# Non-LOCA Release Fractions Feedback

# Feedback on Non-LOCA Release Fractions - Proposed PWR Non-LOCA Power Envelope

# Proposed changes to Section C, RG 1.183 R1

BWR Rod Power History - Range of Applicability  
(Peak Power -15.0 kW/ft BWR (10x10))

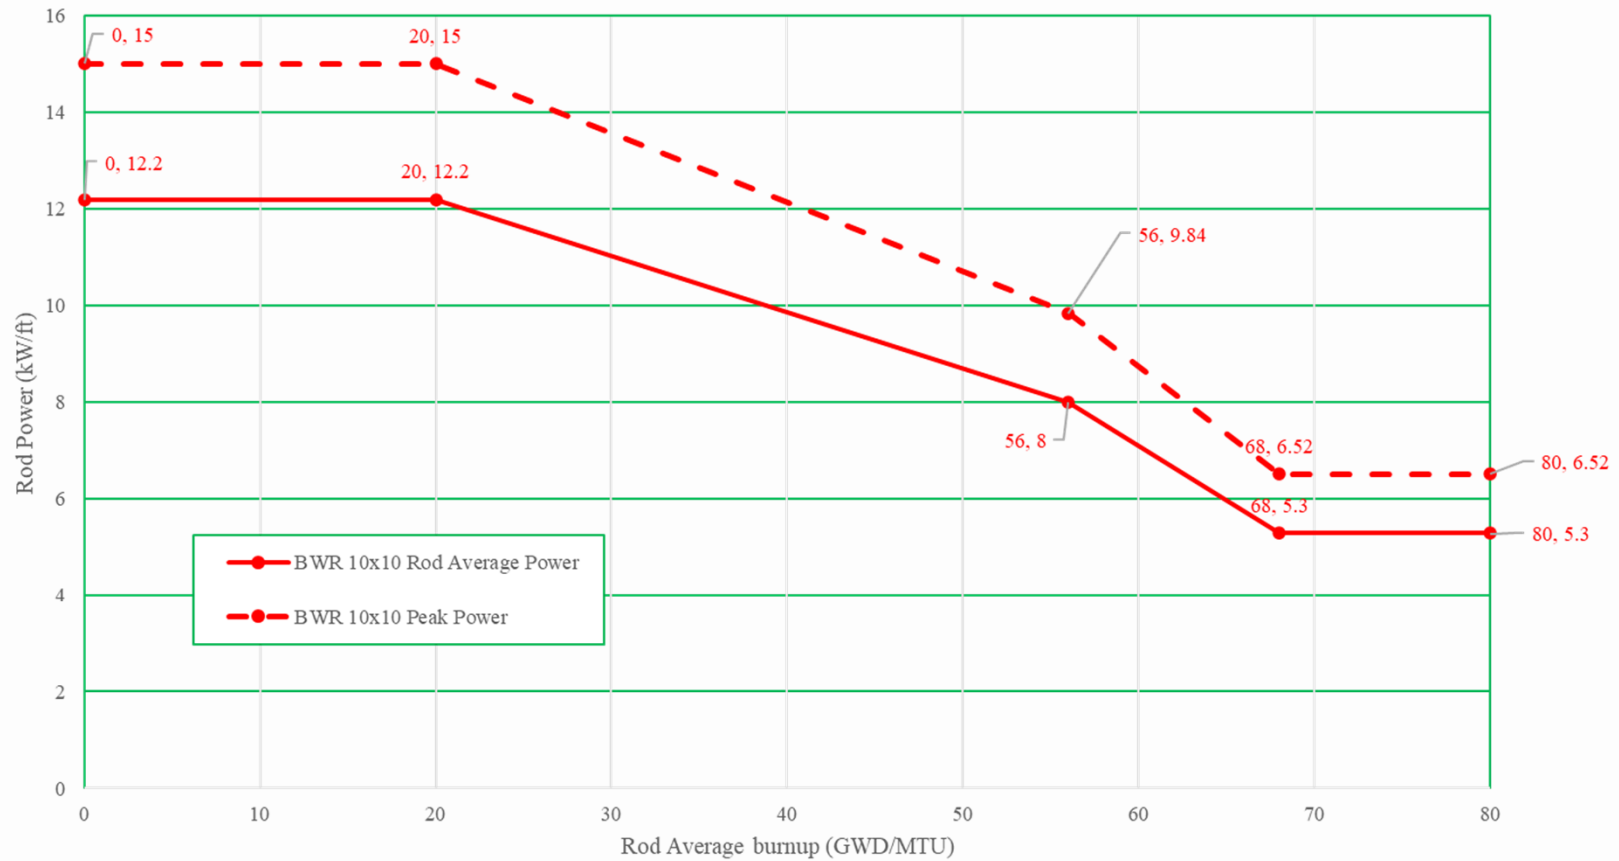
- Modify the third paragraph in Section C (page 9 RG 1.183 R1) to provide the flexibility to use Appendix I in cases where peak exposures, powers or enrichments go outside of the applicability of Figure 1

- This RG applies to non-LOCA models for applicants and licensees with reactor core burnups up to a maximum rod-average burnup of ~~68~~**80** GWd/MTU (and fuel enrichments up to ~~8~~**10** weight-percent uranium-235) for currently approved (as of the issuance of this RG) zirconium-alloy clad UO<sub>2</sub> fuel rod designs at power levels below the burnup-dependent power envelopes depicted in figure 1 of this guide. **For rod designs outside of these limits, Appendix I provides an acceptable analytical technique to calculating maximum steady-state release fractions.**
